Seismic Evaluation Guidance

*Screening, Prioritization and
Implementation Details (SPID) for the
Resolution of Fukushima Near-Term Task
Force Recommendation 2.1: Seismic*

Draft Report, August 2012

Figure 1-1
 Recommended Approach to Respond to Information Request 2.1

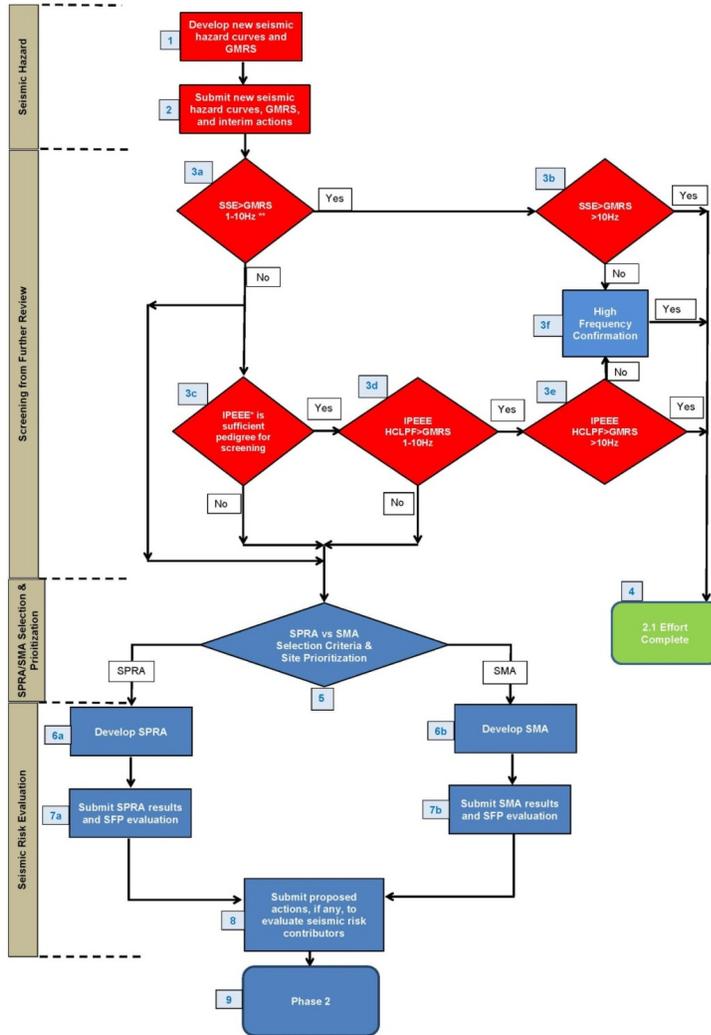
Comment [c1]: Need to be sure that all the screening approaches are incorporated so that everything is incorporated

Figure 3-2
Example Comparison of GMRS to SSE and LHT

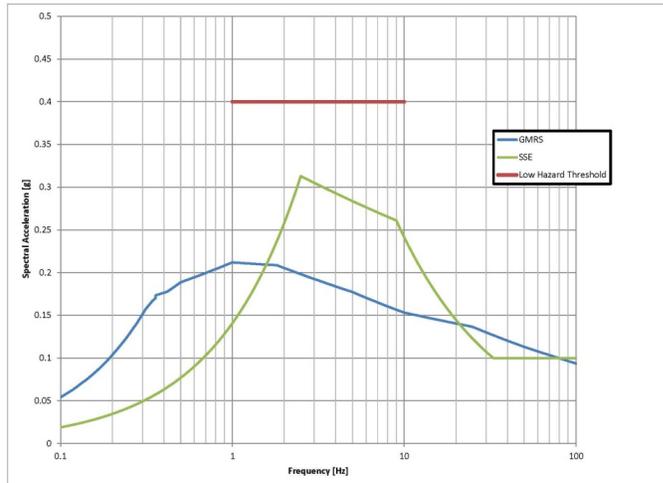
Comment [C2]: This is not a choice for some exceedances.

Figure 3-3
Screening - Example Narrow Exceedances at 2 Hz and 6 Hz

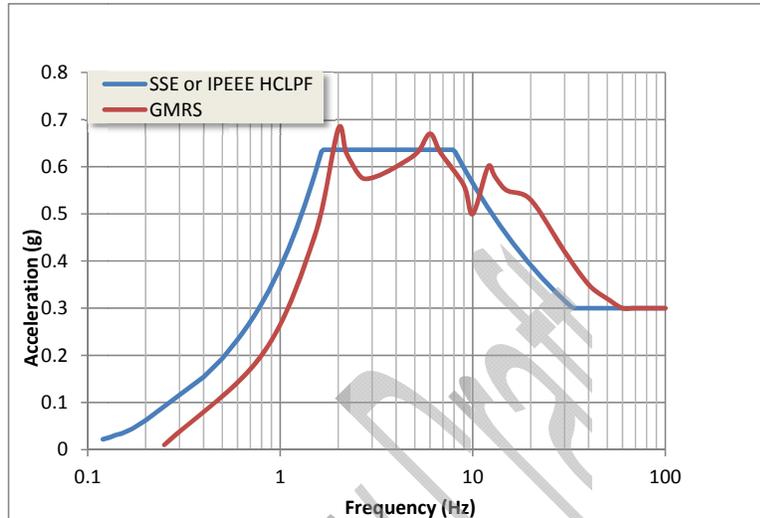
Comment [C14]: Has Figure 3-3 been updated to actually show this scenario? Last meeting it wasn't the case.

Figure 3-5
Sine Beat Test Input Motions

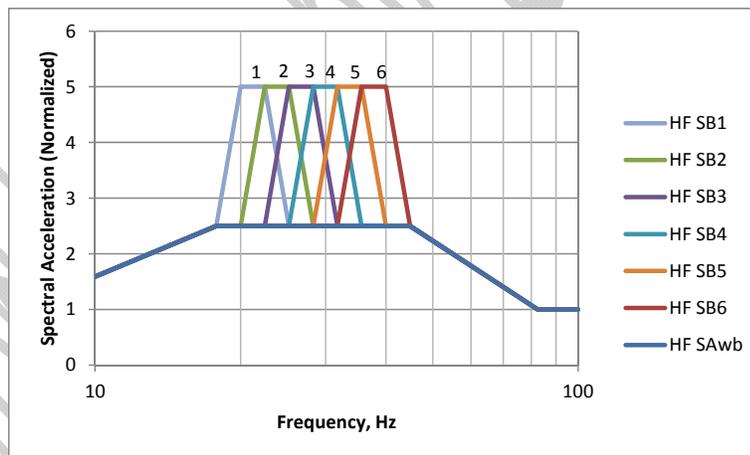
Comment [C23]: Is the sine beat also in the vertical direction?

Figure 6-5
Example of Ground Response Spectra that are Similar

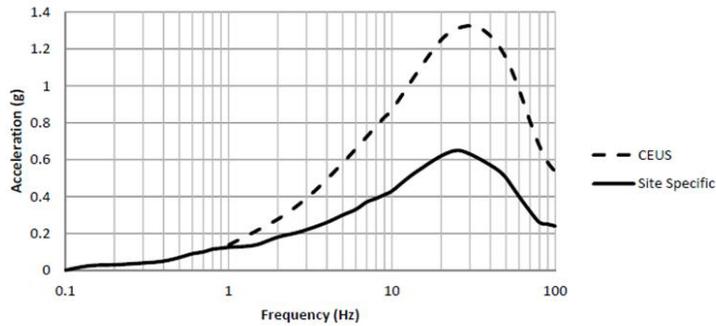
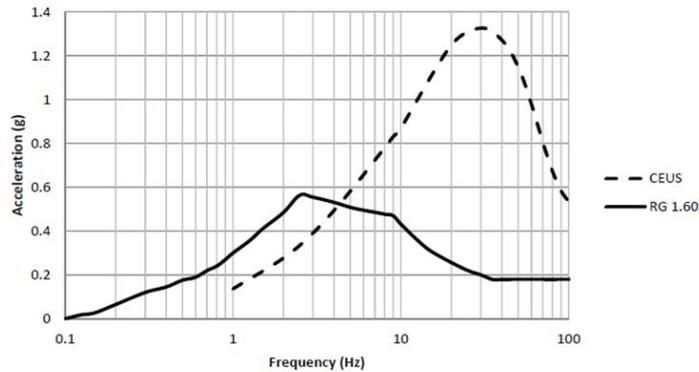
Comment [C25]: The ISG references the SPID in regard to the structural assessments (scaling, existing models, and using fixed base models for soft rock.). This section is focused on PRA, but we need it to also address SMA. Are the changes below all we need to extend it to SMA? Are they noted properly?

Figure 6-7
 Reactor Containment Internal Structure, Operating Floor
 East-West Direction, 5% damping

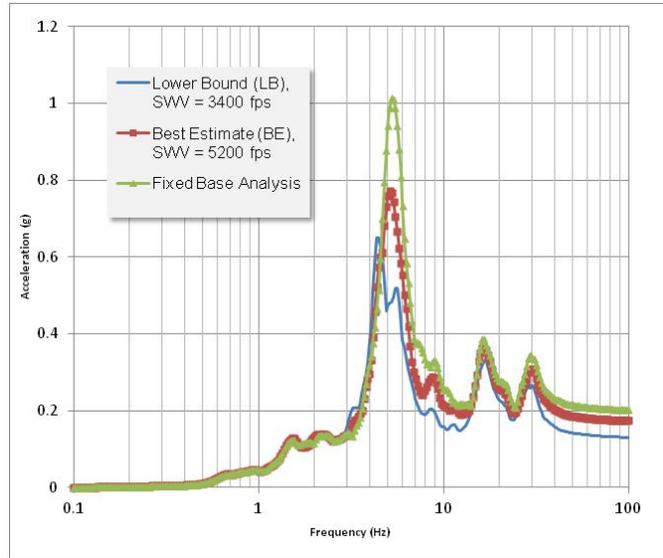
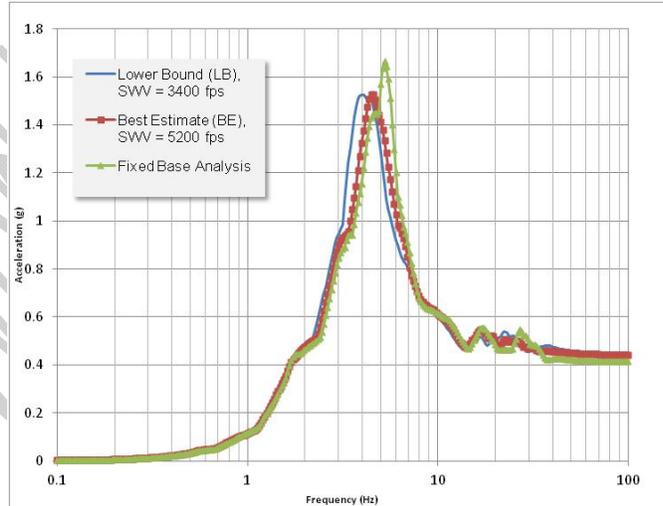
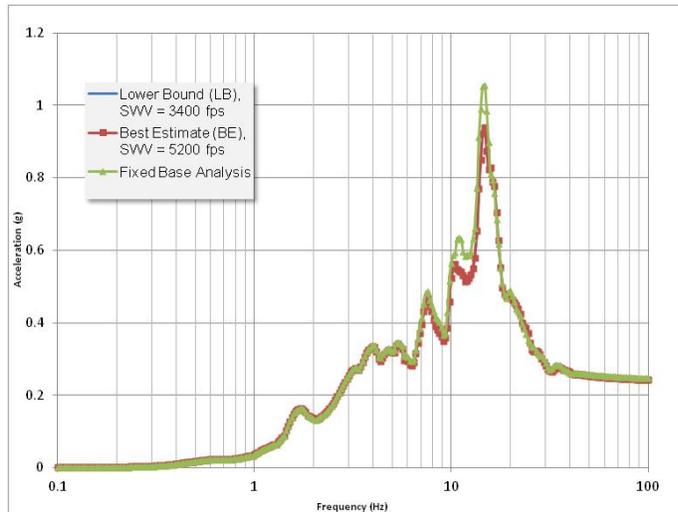
Comment [c29]: The conclusions/caveats from the two study cases need to be repeated in the main body.
